November 30, 1992

Ohana Dwelling Permit (OD 92-288) 2895
Tax Map Key: 1-5-20:36, Lot 820

T M KEY
1-5-20:36 Lot 820

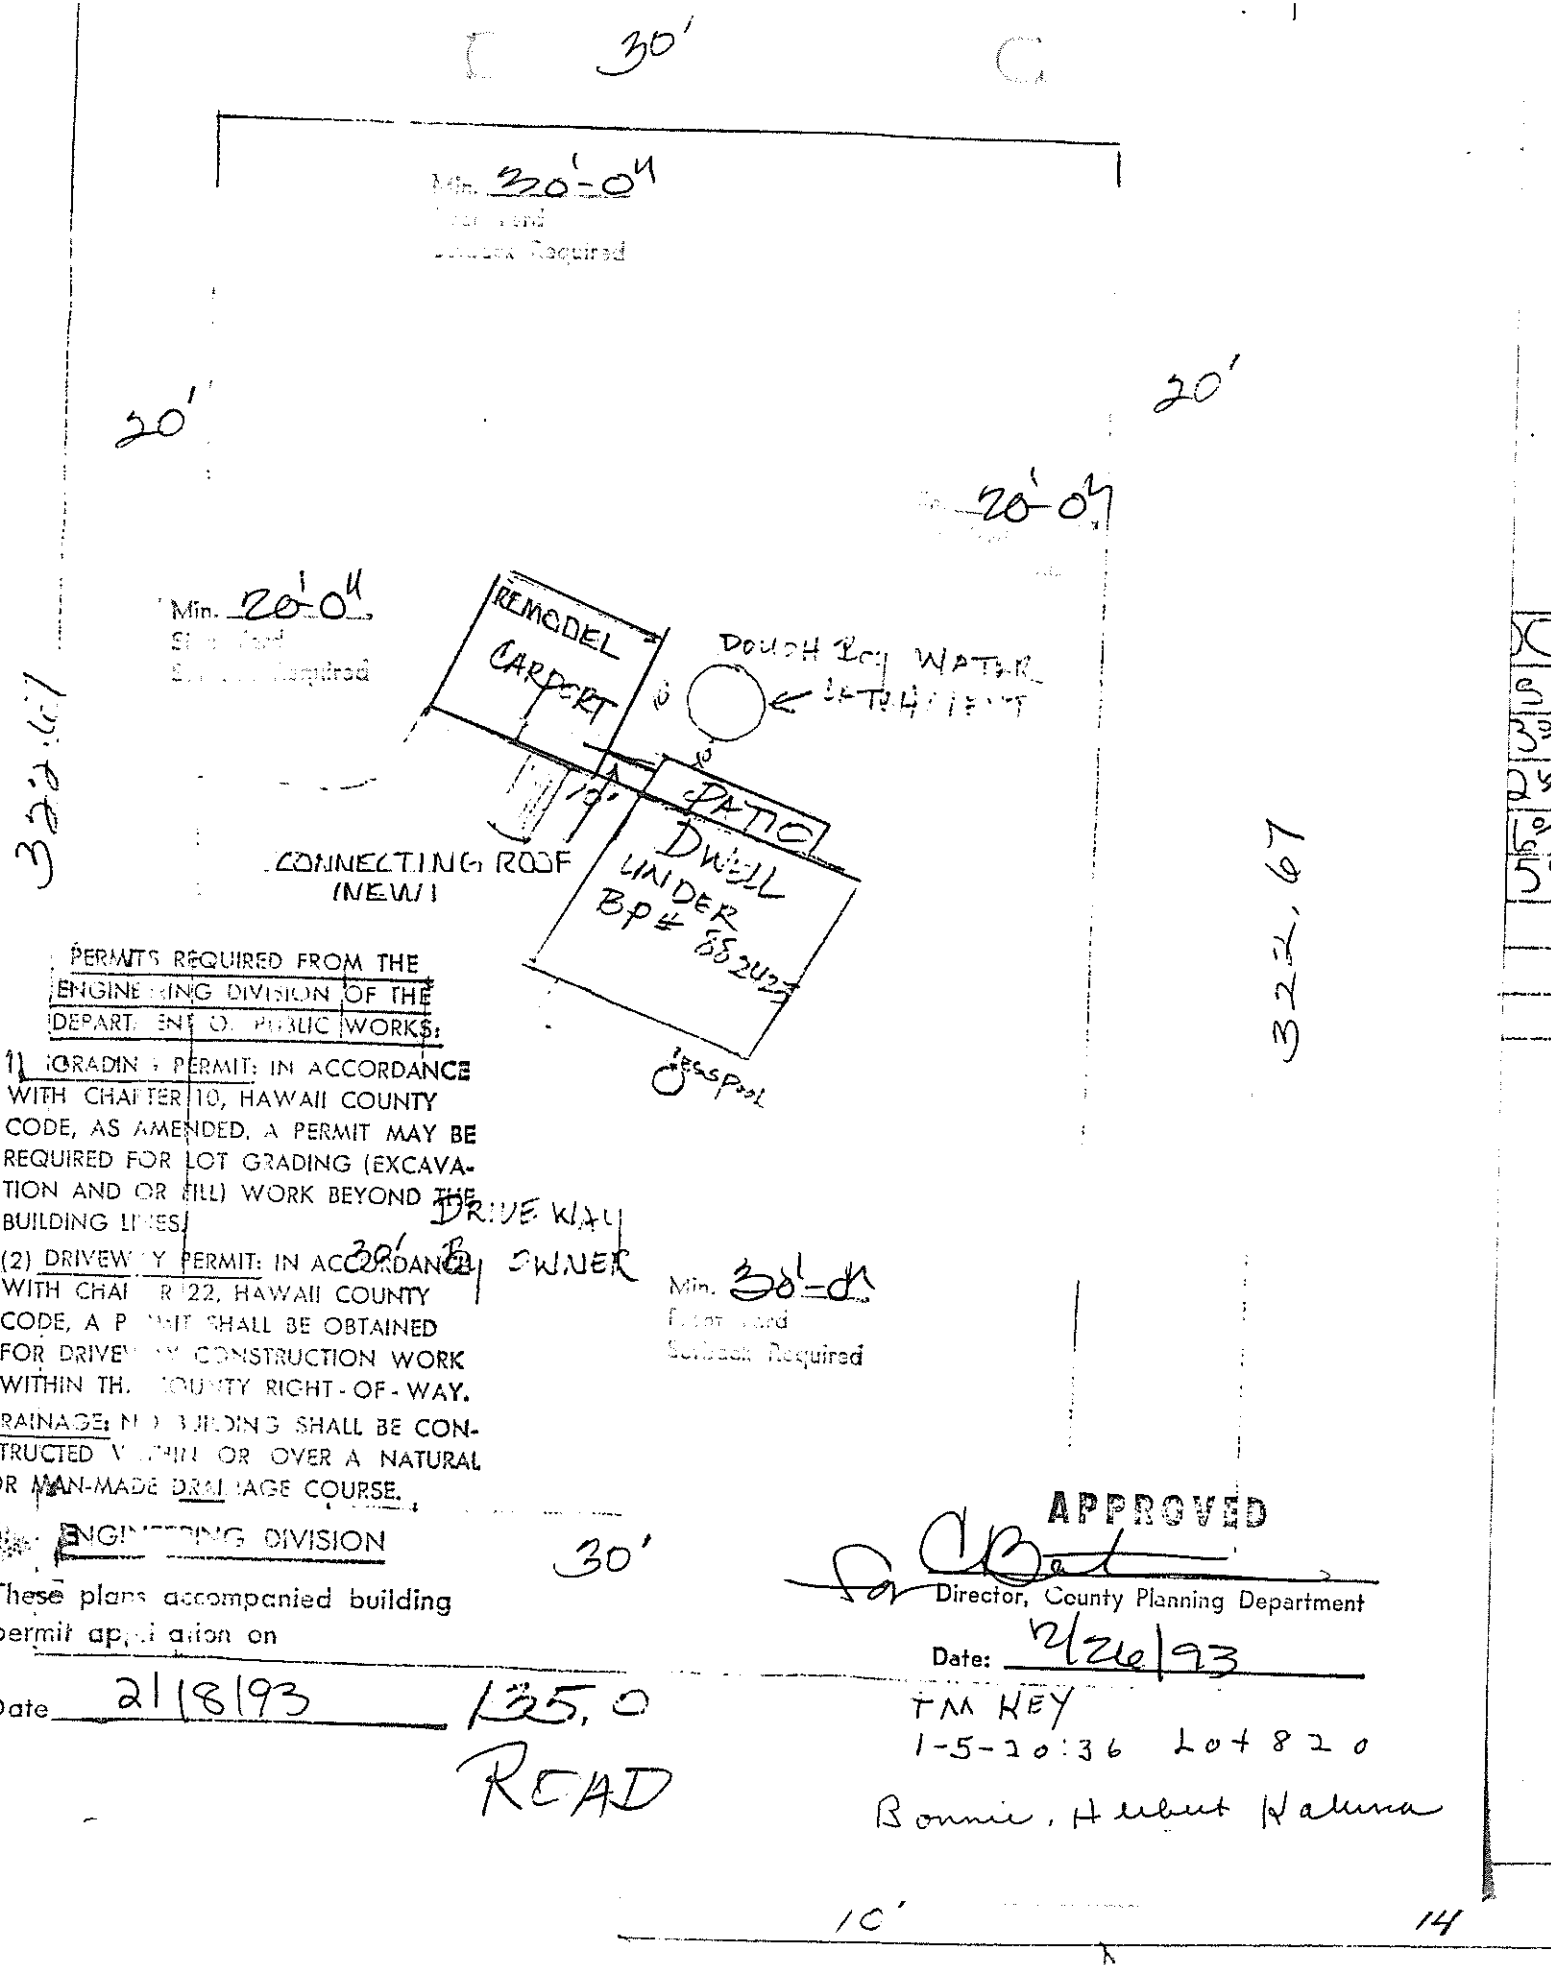
- (b) Off-street parking space for two vehicles is designated on the submitted site plan to fulfill the off-street parking requirement. The off-street parking spaces may not be employed for storage or other use unless and until approved alternative on-site parking arrangements are established.
- (c) All construction drawings together with approved site plan drawn to scale submitted with the ohana dwelling building permit application shall denote location and identify required two (2) off-street parking spaces.
- (d) The ohana dwelling shall conform to all requirements of codes and statutes pertaining to access and building construction.
- (e) The applicant shall conform to State Department of Health standards and regulations and following comment(s) dated September 29, 1992:

The subject proposal is located in a Critical Wastewater Disposal Area. The existing cesspool may service a total of 1,000 gallons per day of wastewater. A total of five bedrooms are allowed in the two dwelling units. A second cesspool is not allowed."

Min. 20'-04"
Setback
Setback Required

Min. 30'-0"
Setback
Setback Required
